Volume 3, Appendix 11-8: Flood Risk Assessment and Drainage Strategy – Lime Down E2 (Tracked)

Revision **~~2~~1**

Planning Inspectorate Reference: EN010168

Document Reference: APP/6.1

Figure 8: Lime Down E2 displacement calculation area – 50,735m²

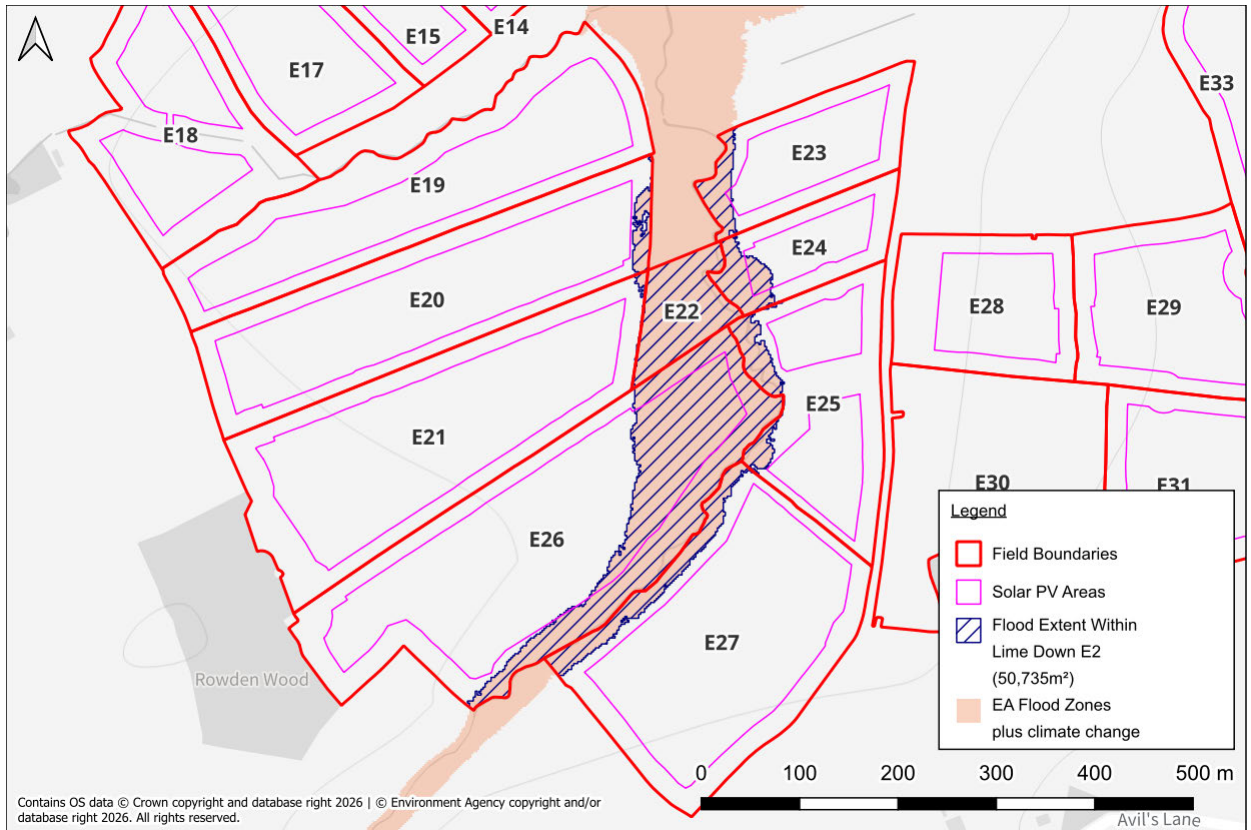
Paragraph 2.3.20	Added text confirming panel supports and fencing would not materially obstruct flood flows.	Updates in response to EA Relevant Representation for Deadline 1 of Examination.
	Figure 8	Inserted new Figure 8 illustrating the areas used to calculate floodplain displacement.	Updates in response to EA Relevant Representation for Deadline 1 of Examination.

2.3.18 The on-site flood extent is approximately 50,735m² - presented in Figure 8. When the total displaced volume of 2.09m³ is distributed across this area, the resulting theoretical increase in flood level is approximately **0.000041mm** (4.1×10^{-5} mm).
